IN THE DRAWINGS

P-PLACEMENT SITE 1
10/018,302
U 013688-5

FIG. 5

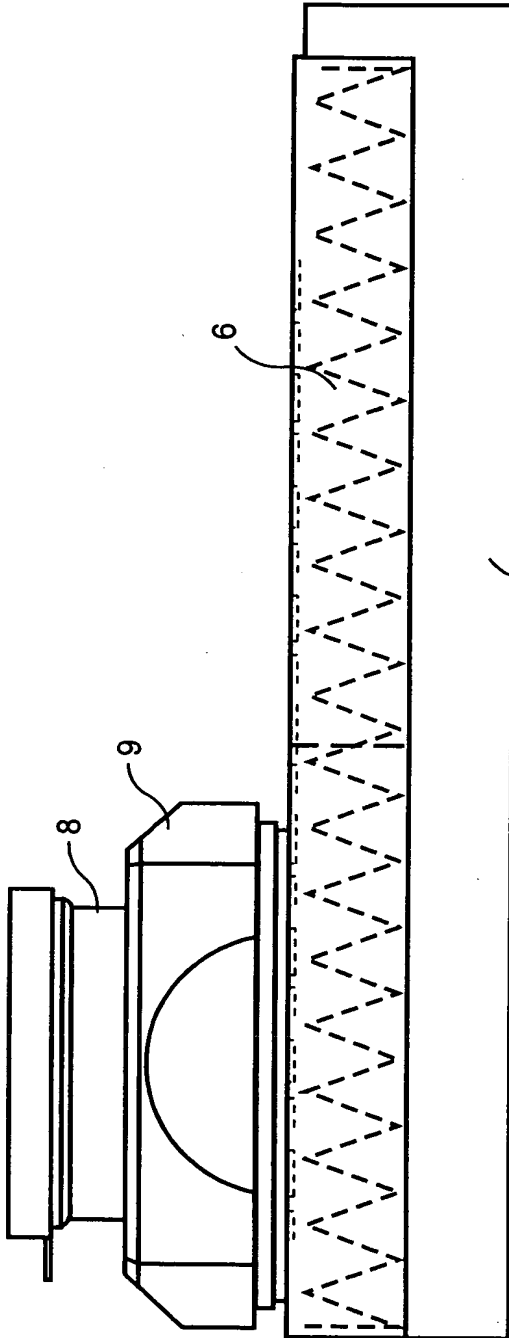
In Figs. 5-11, members 6, 7, 9, 8, 7, 10 and 6, respectively, were originally shaded to indicate heating. On the attached replacement sheets of these Figs. the shading is replaced zig-zag phantom lines that may suggest heating by zig-zag resemblance to electrical resistance but do not introduce such electrical resistance because in phantom lines.

FIG. 9

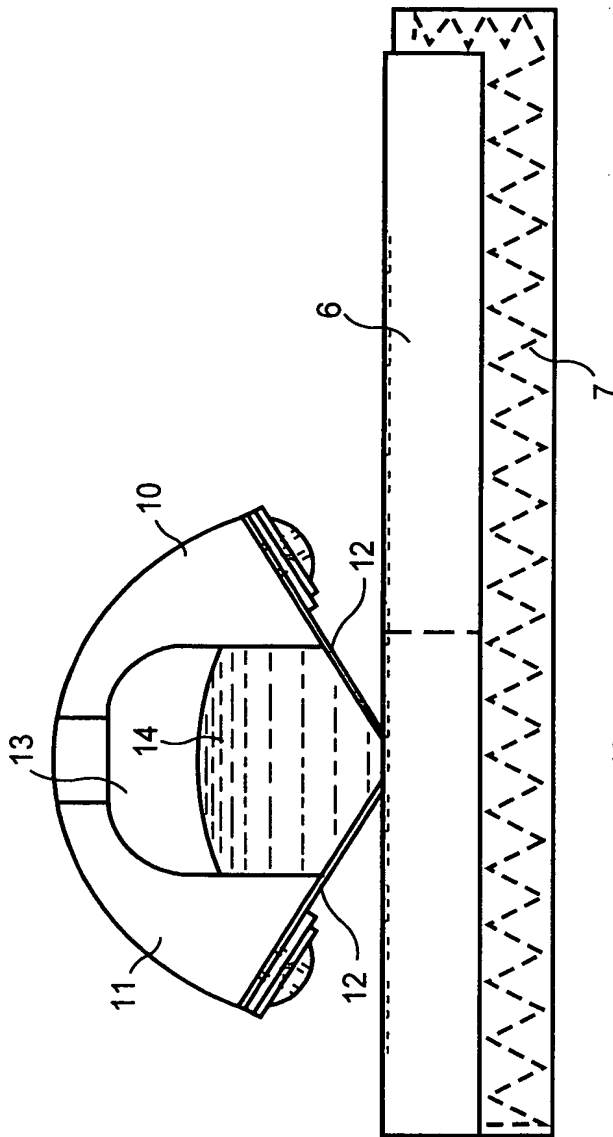
In Figs. 9-11, more familiar liquid-indicating shading is used for ink 14.
